ECE/TRANS/WP.29/GRSG/2006/7
9 February 2006

PROPOSAL FOR DRAFT AMENDMENTS TO REGULATION No. 107

(M₂ and M₃ vehicles)

Transmitted by the informal group on Safety of Wheelchair Users in Vehicles

BACKREST PROVISIONS FOR REARWARD-FACING WHEELCHAIR

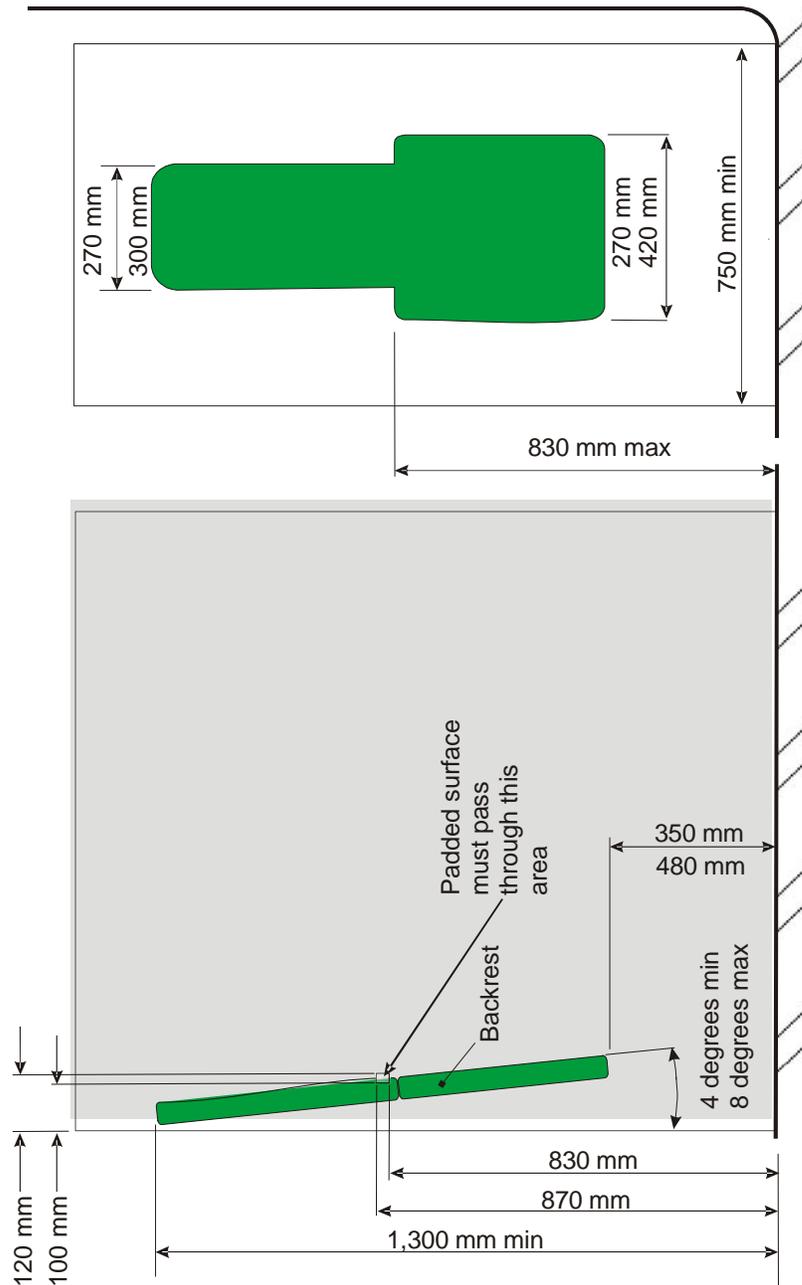
Insert a new Figure 29, to read:

- 3.8.5.1. A backrest fitted to a wheelchair space in accordance with paragraph 3.8.4. shall comply either with the following requirements (see Annex 4, figure 29), or with the requirements of paragraph 3.8.6.:**

- 3.8.5.2. The bottom edge of a backrest shall be at a height of not less than 350 mm and not more than 480 mm measured vertically from the floor of the wheelchair space;**

- 3.8.5.3. The top edge of a backrest shall be at a height of not less than 1,300 mm measured vertically from the floor of the wheelchair space;**
- 3.8.5.4. A backrest shall have a width of:**

- 3.8.5.4.1. not less than 270 mm and not more than 420 mm up to a height of 830 mm measured vertically from the floor of the wheelchair space, and**
 - 3.8.5.4.2. not less than 270 mm and not more than 300 mm at heights exceeding 830 mm measured vertically from the floor of the wheelchair space;**

- 3.8.5.6. The padded surface of a backrest shall form a single and continuous plane;**
- 3.8.5.7. The padded surface of a backrest shall pass through any point on an imaginary vertical plane situated to the rear of the front end of the wheelchair space and situated not less than 100 mm and not more than 120 mm from the front end of the wheelchair space measured horizontally and not less than 830 mm and not more than 870 mm from the floor of the wheelchair space measured vertically; and**

- 3.8.5.8. A backrest shall be capable of bearing a load of 250 ± 20 daN applied for a minimum of 1.5 seconds by means of a block 200 mm x 200 mm in the longitudinal plane of the vehicle towards the front of the vehicle to the centre of the padded surface of the backrest at a height of not less than 600 mm and not more than 800 mm measured vertically from the floor of the wheelchair**

space. The backrest shall not deflect more than 100 mm or suffer permanent deformation or damage.

- 3.8.5. and
3.8.6. The position, shape and method of testing the backrest is added to ensure that it suits a wide range of wheelchair designs and provides adequate protection to a wheelchair user. Provision is made for an alternative means of support if it can offer an equivalent level of protection.

Figure 1

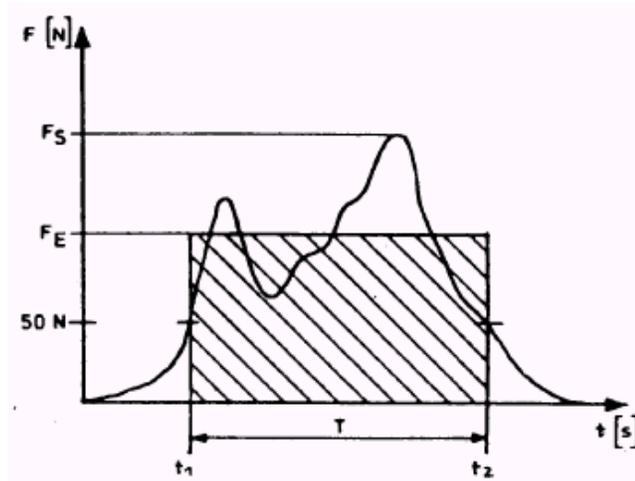
The closing of a power-operated door **and the operation of a power-operated ramp are dynamic processes**. When a moving door **or ramp** hits an obstacle, the result is a dynamic reaction force, the history of which (in time) depends on several factors (**for example**, mass of the door **or ramp**, acceleration, dimensions).

2.1. Closing **or reactive** force $F(t)$ is a time function, measured at the outer edge of the door **or ramp** (see paragraph 3.2. below).

2.2. Peak force F_S is the maximum value of the closing **or reactive** force.

2.3. Effective force F_E is the average value of the closing **or reactive** force related to the pulse duration:

t_1 = threshold of sensitivity, where the closing **or reactive** force exceeds 50 N;

t_2 = fade-away threshold, where the closing **or reactive** force becomes less than 50 N.

- 2.5. The relation between the above parameters is shown in figure 1 below (as an example):

Figure 2

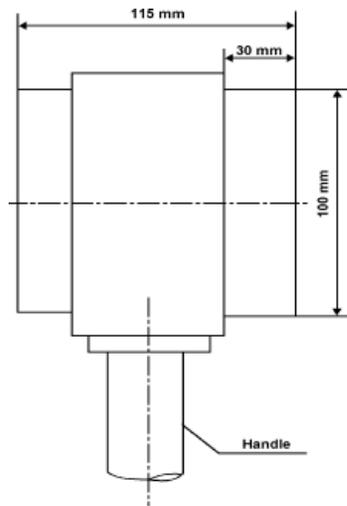
- 3.5. The deviation of the reading from the rated value shall not be more than ± 3 per cent.
4. Measuring device
- 4.1. The measuring device shall consist of two parts: one handle and one measuring part which is a load cell (see figure 2).

- 4.2. The load cell shall have the following characteristics:
- 4.2.1. It shall consist of two sliding housings with the outer dimension of 100 mm in diameter and 115 mm in width. Inside the load cell a compression spring shall be fitted between the two housings such that the load cell can be pressed together if an appropriate force is applied.

- 4.2.2. The stiffness of the load cell shall be 10 ± 0.2 N/mm. The maximum spring deflection shall be limited to 30 mm so that a maximum peak force of 300 N is achieved.
